Subject: Oregon Wild comments on the Wagon Road Pilot EA

Please accept the following comments from Oregon Wild concerning the [Wagon Road Pilot EA](#), DOI-BLM-OR-C040-2011-0008-EA, dated November 2011. http://www.blm.gov/or/districts/roseburg/plans/files/Roseburg_Pilot_Scoping_Letter_Notice_Map_Final.pdf Oregon Wild represents about 7,000 members and supporters who share our mission to protect and restore Oregon's wildlands, wildlife, and water as an enduring legacy. Our goal is to protect areas that remain intact while striving to restore areas that have been degraded. This can be accomplished by moving over-represented ecosystem elements (such as logged and roaded areas) toward characteristics that are currently under-represented (such as roadless areas and complex old forest).

Jazz Thin, Mt Hood NF, 2011

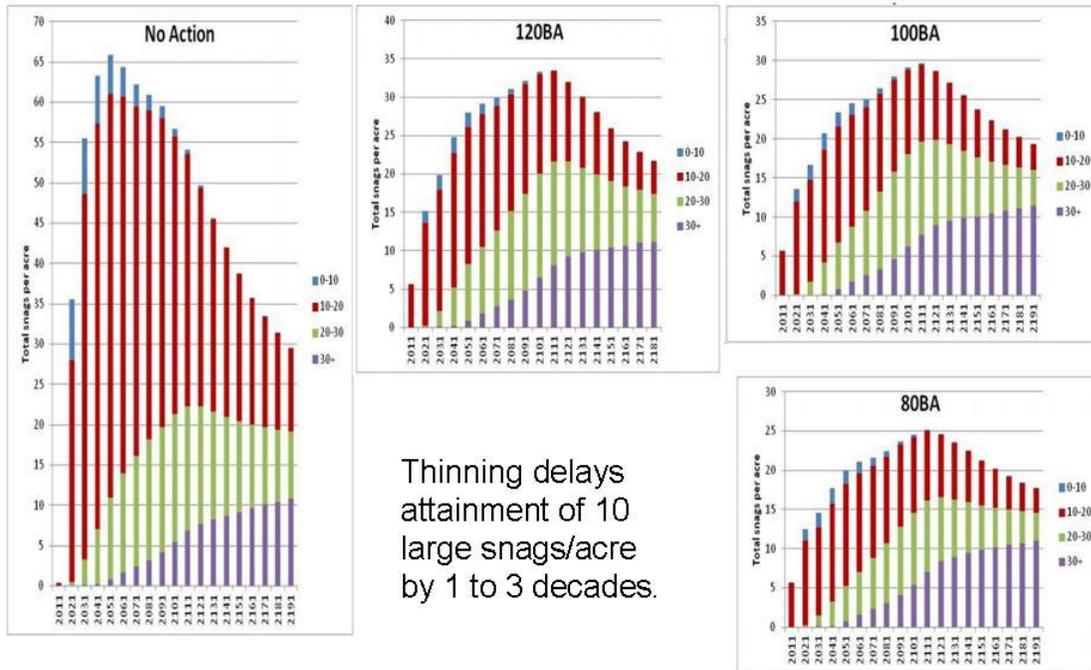
Second, if this stand responds to thinning like many other dense stands analyzed by the BLM and USFS in recent years, more total wood and more large wood will likely be recruited under the no action alternative than by the density management alternative. See for instance, these charts from the Jazz Thin Project on the Mt Hood NF. No action produces more total wood and more large wood.

[Note: This analysis presents an average result from thinning plus adjacent untreated areas, such as riparian reserves.]
